This Service Information bulletin supersedes SI M17 07 12 **dated September 2012.**

Service Action: Retrofit of the Engine Coolant Temperature Sensor

All with manual transmission and either the N14, N16 or N18 engine

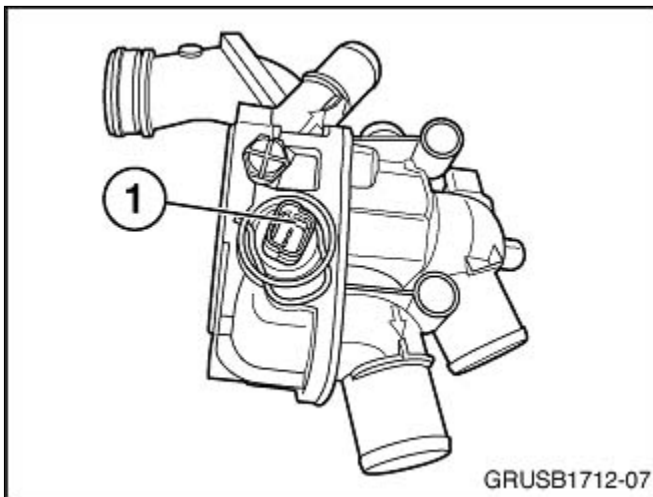
NEW Note: Vehicles equipped with the N16 engine may have had repairs performed prior to this Service Action, so that installing this remote sensor and hose is no longer required.

NEW This Service Action does not apply to any N16 engine that had a thermostat replaced with P/N

11 53 7 534 521.

NEW The 11 53 7 534 521 thermostat needs to be installed in conjunction with an engine electrical wiring harness replacement.

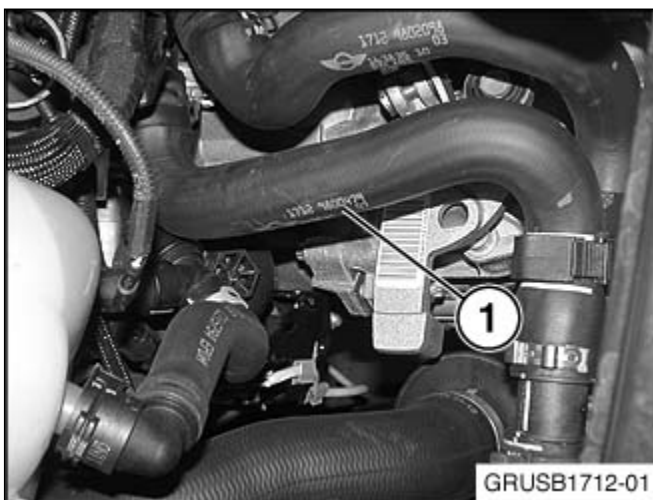
NEW Checking for updated thermostat: The 11 53 7 534 521 thermostat has a replaceable engine temperature sensor (1).

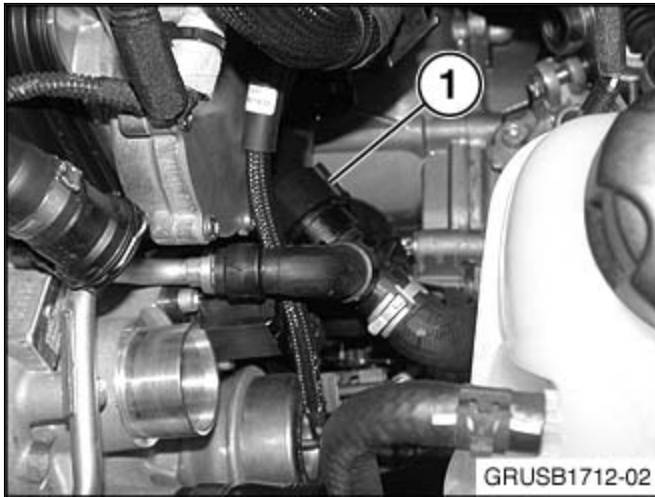
Remove the fresh air intake tube and the intake tube from the air box to the turbo to gain access to the coolant hose.

Remove the coolant hose (1). This hose will not be reused.

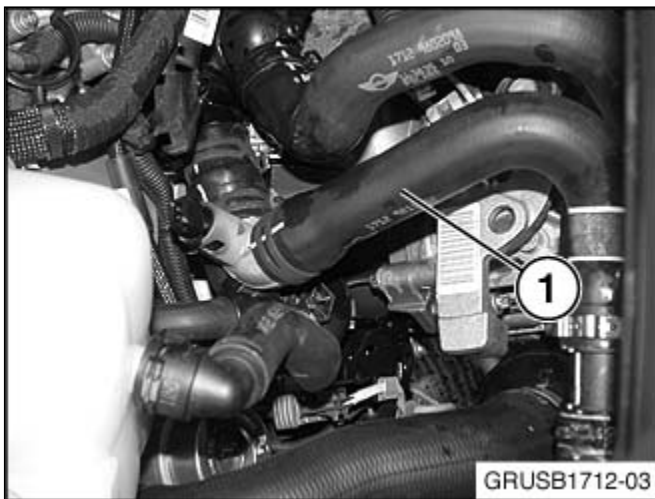
N18 engine only! Install spacer P/N 64 53 7 578 707 (1) on the coolant line as shown.

Note: The spacer needs to stay in this position when installing the new coolant hose P/N 17 12 7 647 004 (next step).

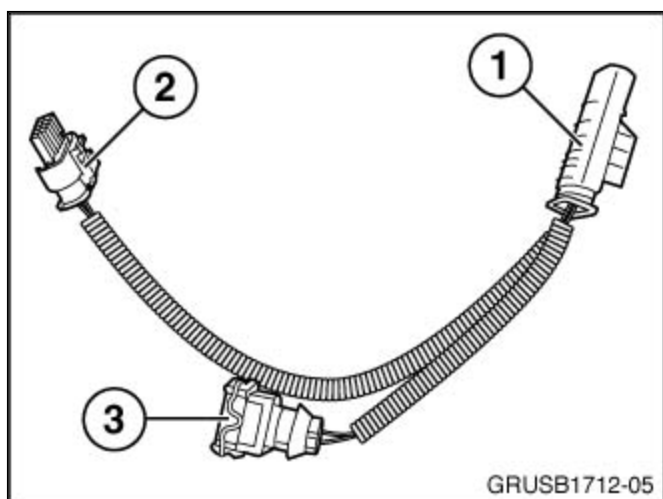
Install the new coolant hose with sensor P/N 17 12 7 647 004 (1).

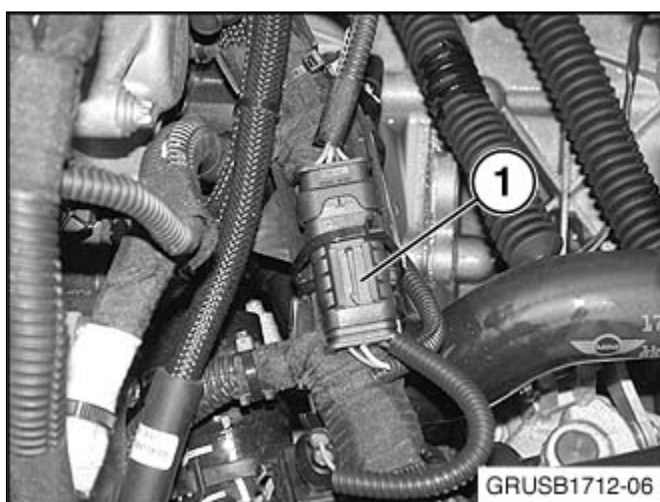
Unplug connector X6279 from the engine thermostat (1).

Plug connector X6279 into the 4-pin male connector (1) of adapter harness P/N 12 51 7 647 200. Insert the 4-pin female connector (2) of the adapter harness into the engine thermostat. Plug the 2-pin female connector (3) from the adapter harness into the engine temperature sensor of hose P/N 17 12 7 647 004.
